**Written submission from  
Northwatch**

**Ontario Power Generation Inc. -  
Darlington Waste Management Facility**

# Northwatch Comment on the Application by Ontario Power Generation's to Renew its Darlington Waste Management Facility operating licence

Ref. 2023-H-09

**Figure 1** : A to-scale schematic of 4 'modules' of 48 tubes each with a pair of bundles showing minimal clearances in all dimensions

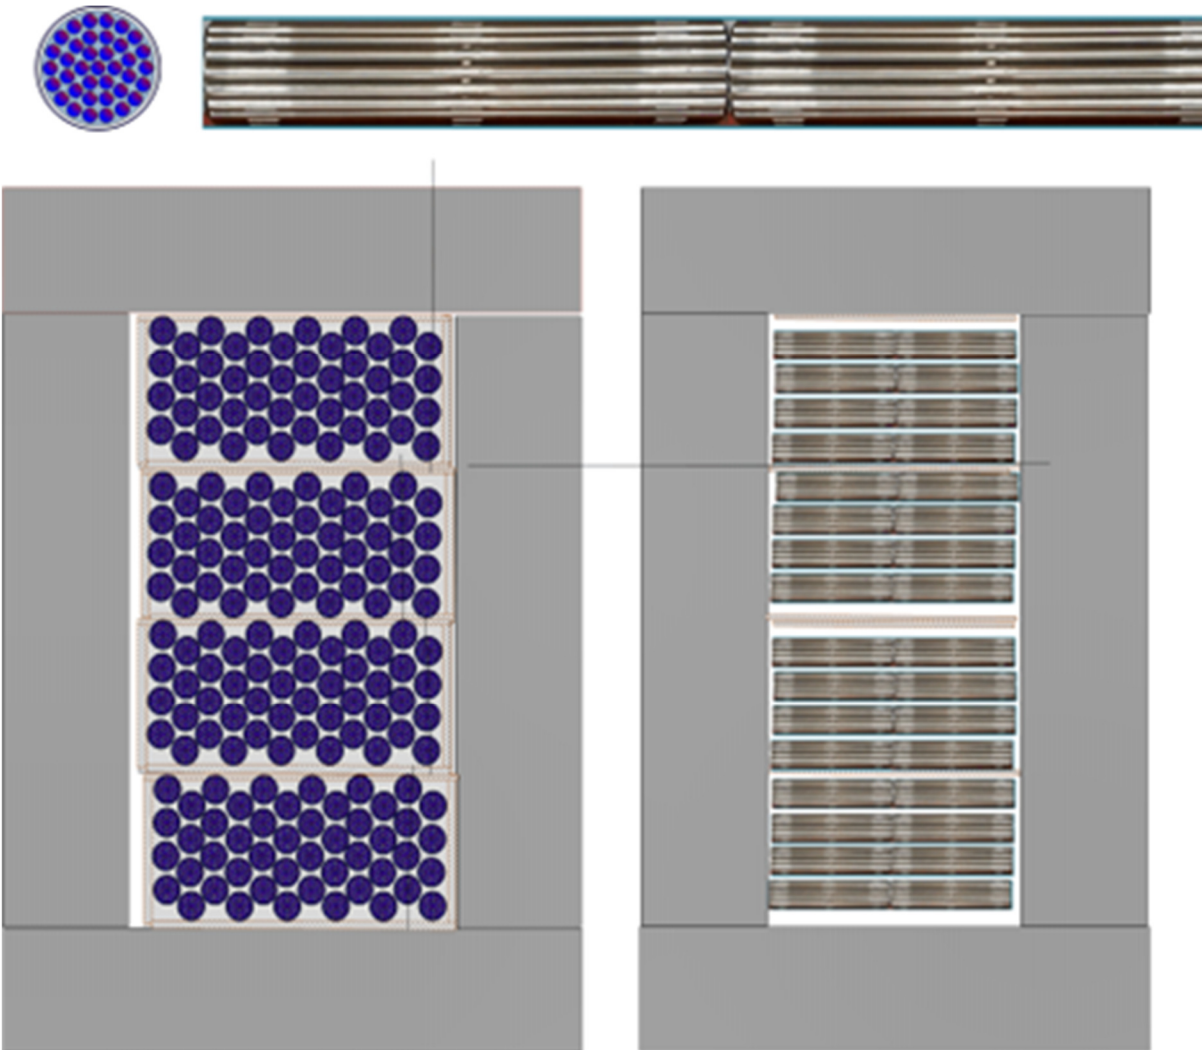
The DSC cavity is 1.06m wide; 1.22m long and 6.5m high and is packed with 4 spent fuel modules, each housing 48 storage tubes with a pair of spent fuel bundles each stored there since their removal from the reactor. Darlington safety report states that the fuel modules contain 96 fuel bundles in 4 rows of 12 storage tubes. This is not quite incorrect. Such a straight layout will not fit in the DSC ( $12 * 0.12 = 1.44\text{m}$  which is  $>$  available width of 1.22 m). The fuel storage tubes are in 8 staggered rows of 6 tubes each, with alternate rows pretty much sitting on each other and shifted vertically.

It would also be a greater challenge to ensure adequate heat removal when that module is tightly enclosed in a concrete cask upon dry storage (Figure 1 through Figure 4). There is just very little clearance between the 32 rows of 192 storage tubes, between 4 modules or between cask steel walls and ends of 384 bundles packed inside the cask (Figure 1). In this case, fuel will not have the benefit of a circulating current of natural convection gas flows to remove heat from the fuel elements and thus remain at elevated temperature throughout its journey; certainly much higher compared to a design in which it was put in a cask that permitted a substantive convective currents along the fuel surfaces; one that that was deigned against some commonly used criteria like the CANDU MACSTOR, 10 odd LWR dry storage cask designs like CANSTORE and others that we examined and evaluated their thermal modelling / analysis of. What the OPG DSC essentially is a space to dump the fuel modules in and hope for the best. OPG has failed to provide any information on the design requirements, safety targets for these DSCs and how they are met with this design.

Figure 2: Idealized OPG sketch of 48 storage tubes in each of four fuel modules in DSC

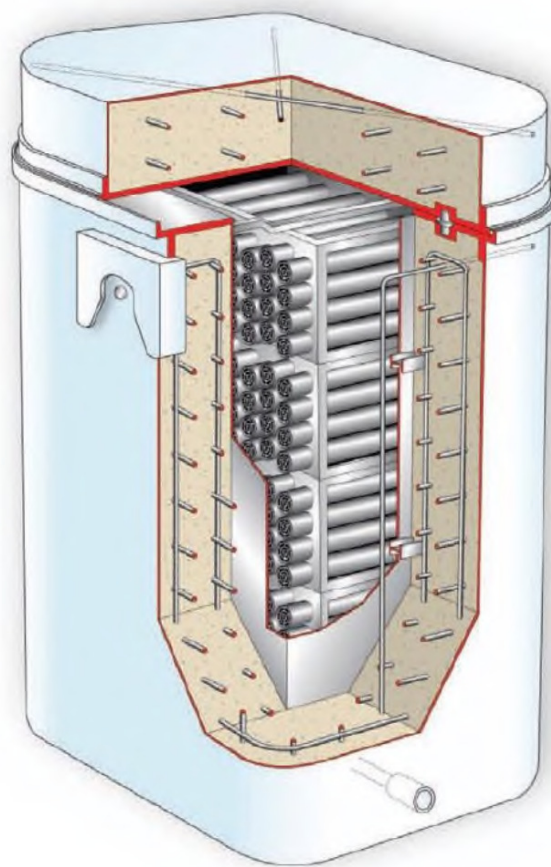
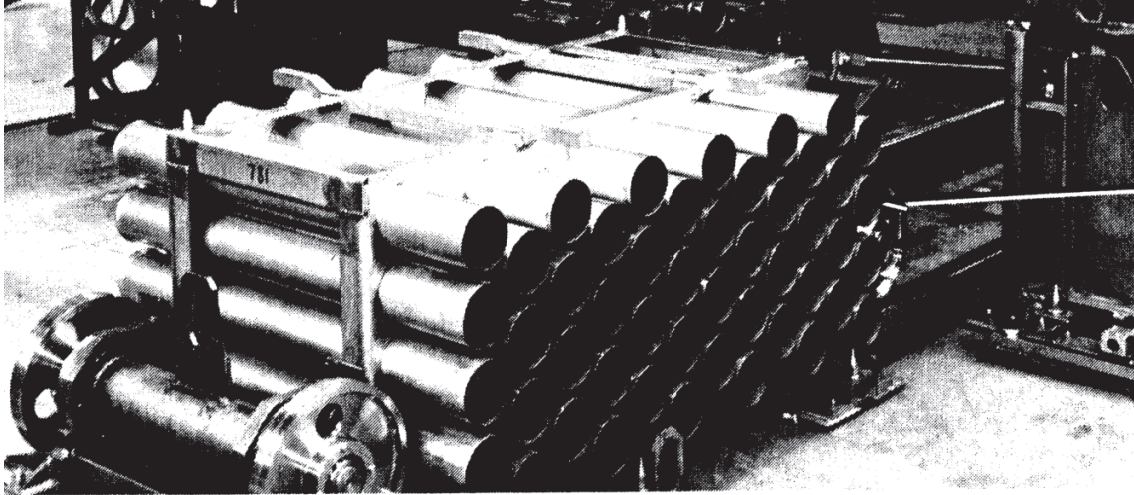
An image of an ordered, well spaced separated from each other 48 storage tubes as illustrated in Figure 2 is in conflict with the actual photograph of a fuel module in Figure 3 where it is implied that a pair of vertical plates with holes separate various fuel tubes. The actual picture in Figure 3 suggests fuel tubes are practically piled on each other; sitting very close to on top of each other, as illustrated in Figure 4. Once loaded with 45 kg of fuel in each tube, the module of 48 tubes is a formidable handling challenge and a steel mesh is installed on the tube ends to stop any spillage.

Once you examine the spent fuel placement in dry and wet storage in these three figures, it becomes apparent that the Darlington OPG Dry Storage Cask is an unventilated closed container with practically no means of convective heat removal from the spent fuel bundles encased in storage

**Figure 3: A photograph of fuel module showing stacked fuel storage tubes each of which will hold 2 bundles** (Reference 6)

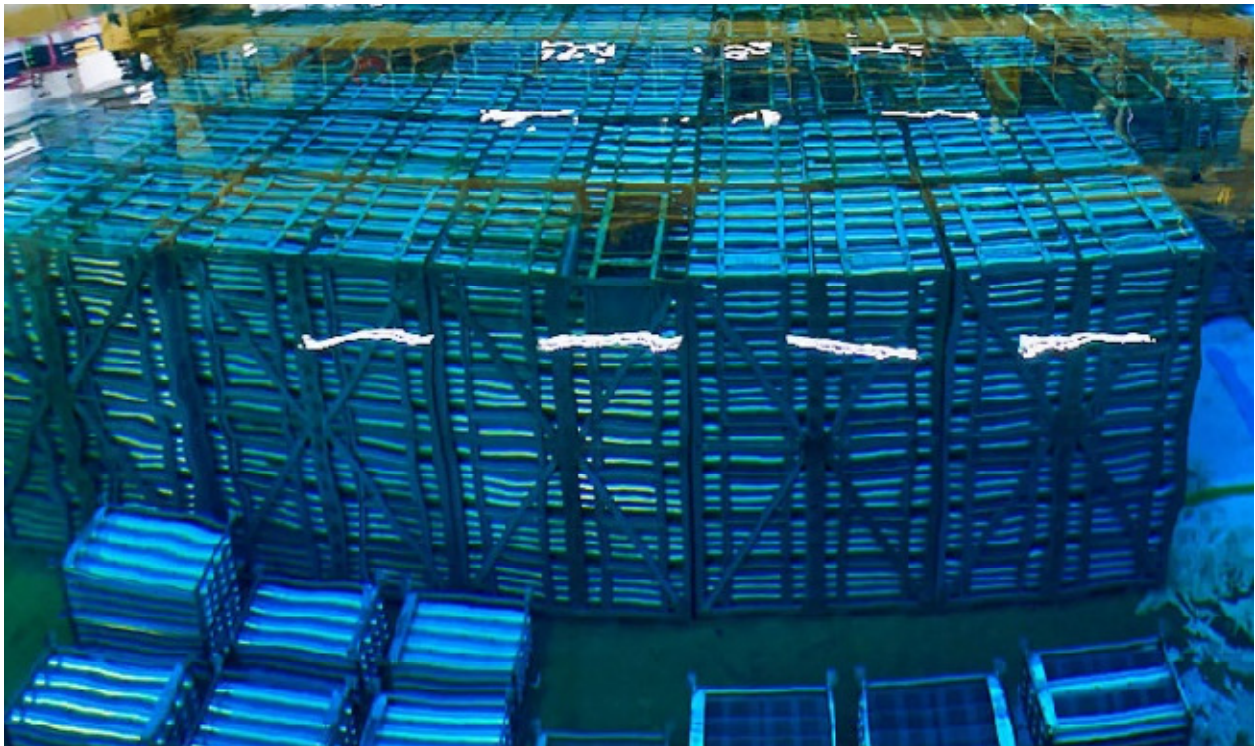
tubes. There also are plenty of horizontal surfaces for excess water to pool and be absorbed into, and present challenges to evacuation of water by vacuum drying. R&D work at institutions that partake in DSC storage designs has demonstrated that orders of magnitude higher quantities of water is still retained after vacuum drying. Experience in Pharmaceutical industry confirms that deviation from the simplistic modelling typically made of a thermodynamically predictable small quantity. This water is instrumental in long term sheath decay and fuel failures.

A spent fuel dry storage system is required to dissipate fuel decay and chemical heat by convection of the enveloping gas moving around the fuel elements within the bundles. However, this OPG DSC design does everything to inhibit convective currents around fuel elements by first encasing two bundles in a tube, figuratively suffocating them, and then stacking the tubes in a horizontal geometry very close each other and close as well too to the walls of the thick steel lined concrete filled container. Figure 1, drawn largely to scale, shows the absence of any clear paths for heat removal and potentially practically zero convective heat transfer from the 3<sup>+</sup> rings of fuel elements within the fuel bundles firmly engaged within the respective storage tubes. The wet stored 48 tube module is carried over to the dry storage cask and snuggled into its deep cavity underwater. A total of four storage modules populate a DSC.

**Figure 9:** NWMO planned configuration for ultimate storage of CANDU Darlington fuel bundles (Source : NWMO)

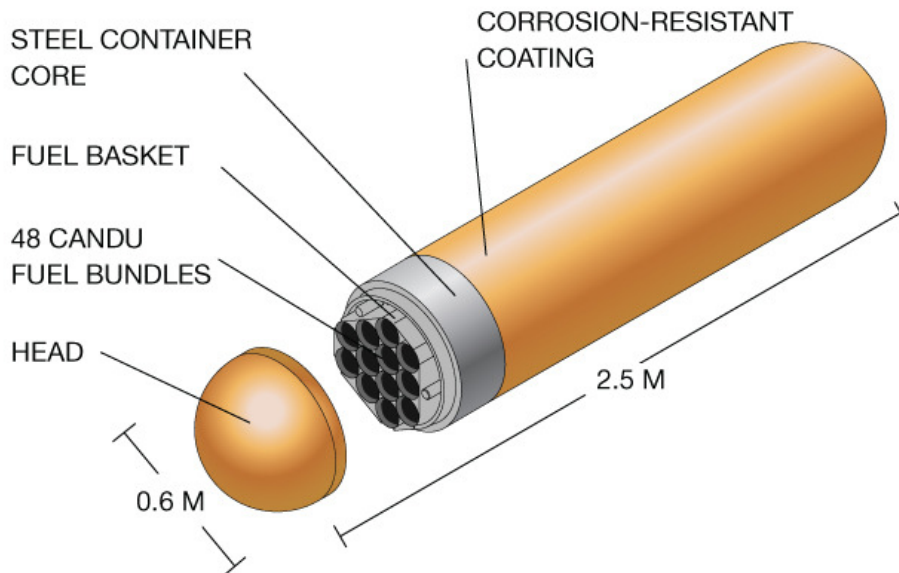
And some food for thought for the Commissioners. Can this industry not be asked to design a single spent fuel bundle storage container for use from receipt from the reactor to final resting<sup>1</sup> at the bottom of whatever the NWMO comes up with so that there is no repackaging of what are expected to be millions of ultimately fragile brittle spent fuel bundles, ever? And should that not be a condition for renewal of license for the plant and explicable tied to it the spent fuel wet and dry storage, transport and disposal outcomes? Imagine going manually through several million spent fuel bundles in ‘hot cells’ as envisioned by the NWMO plans in a Used Fuel Packaging Plant (UFPP) at final repository site and then imagine the resistance from any community to such an operation within their boundaries once they realize the associated hazards in manual fuel processing at ground level in buildings that themselves become contaminated.

We need to put our best minds together at this instead of continuing to repeat the spent fuel storage Cask design errors in the nuclear waste management and its present seemingly weak supervision. The Commissioners should take a hard look at this application and at their own mandate to act in public interest and common good and ask OPG to do some real R&D to come up with a new design prior to extending their license. And please ask them to put some internationally recognized radiation warning label on those now shiny, freshly painted DSCs.

**Figure 10:** MACSTOR the other CANDU PHWR dry storage solution

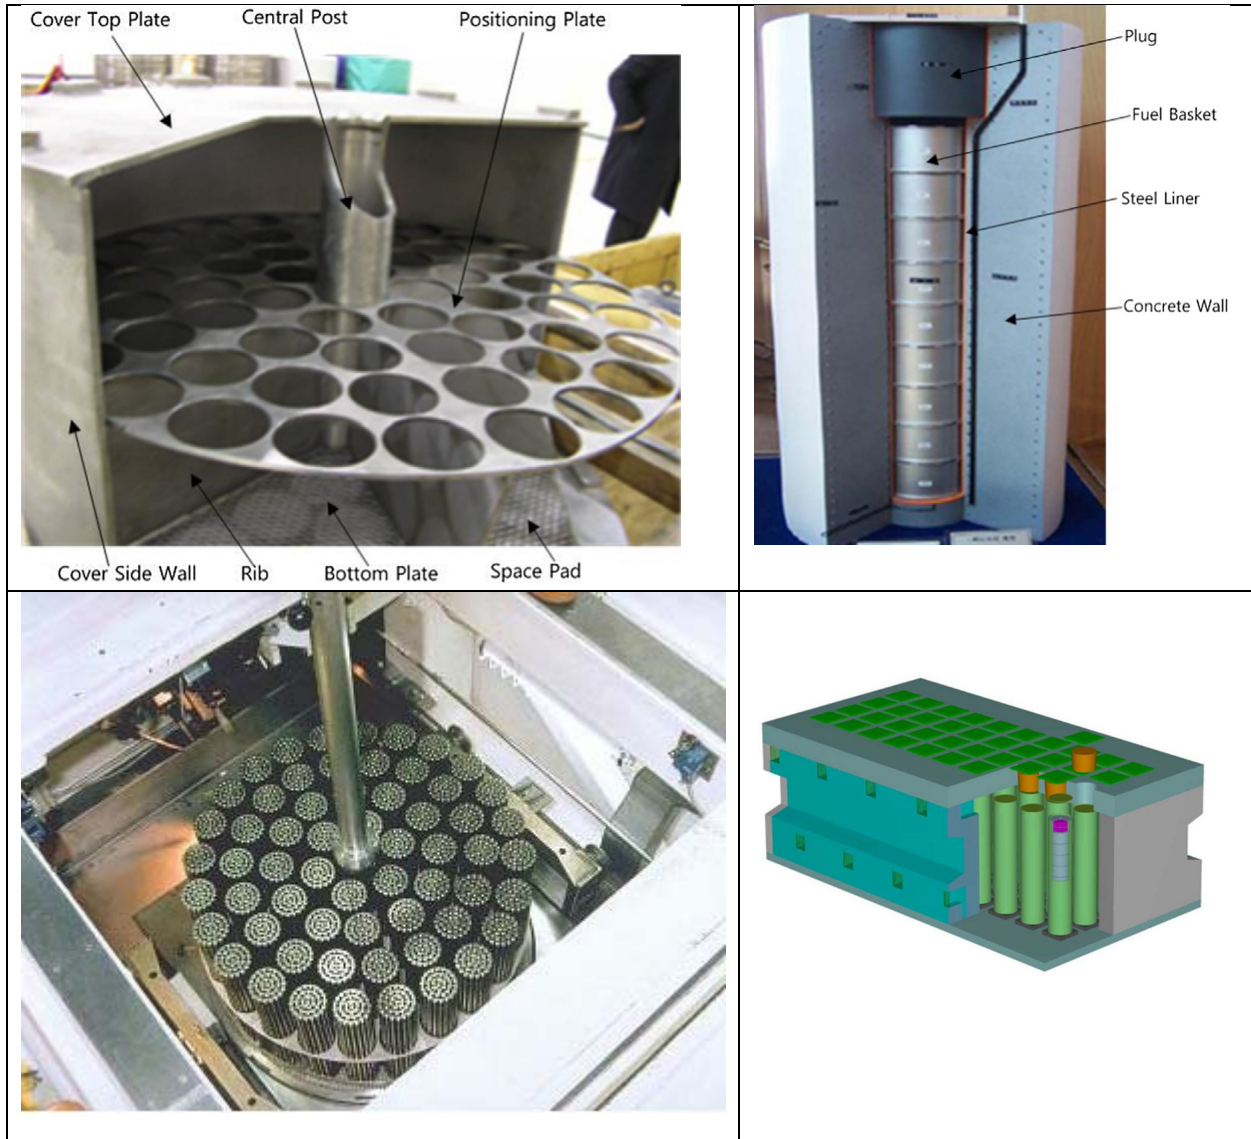
CANDU PHWR spent fuel is stored in both ventilated (CANDU 6 MACSTOR) and un-ventilated, closed casks (OPG DSC casks). The same is true for LWR spent fuel casks. In almost all cases with positive outcomes, the design is typically such that the fuel decay heat is transferred by thermosyphon of enveloping inert gas over free standing, unloaded, vertical fuel bundles within a sealed metal casing in turn transferring heat out on its external surface by recirculating or once through convection to or through a surrounding concrete cask.

The fuel cavity inside the metal casing is earlier emptied of water by vacuum drying and refilling with an inert gas like Helium. Those who monitor the state of fuel inside by sophisticated means since developed or by physically examining the fuel after years of storage, report that significant and unanticipated amounts of water likely still remained within the casing no matter how well they thought the vacuum drying process was carried out. (reference 25)
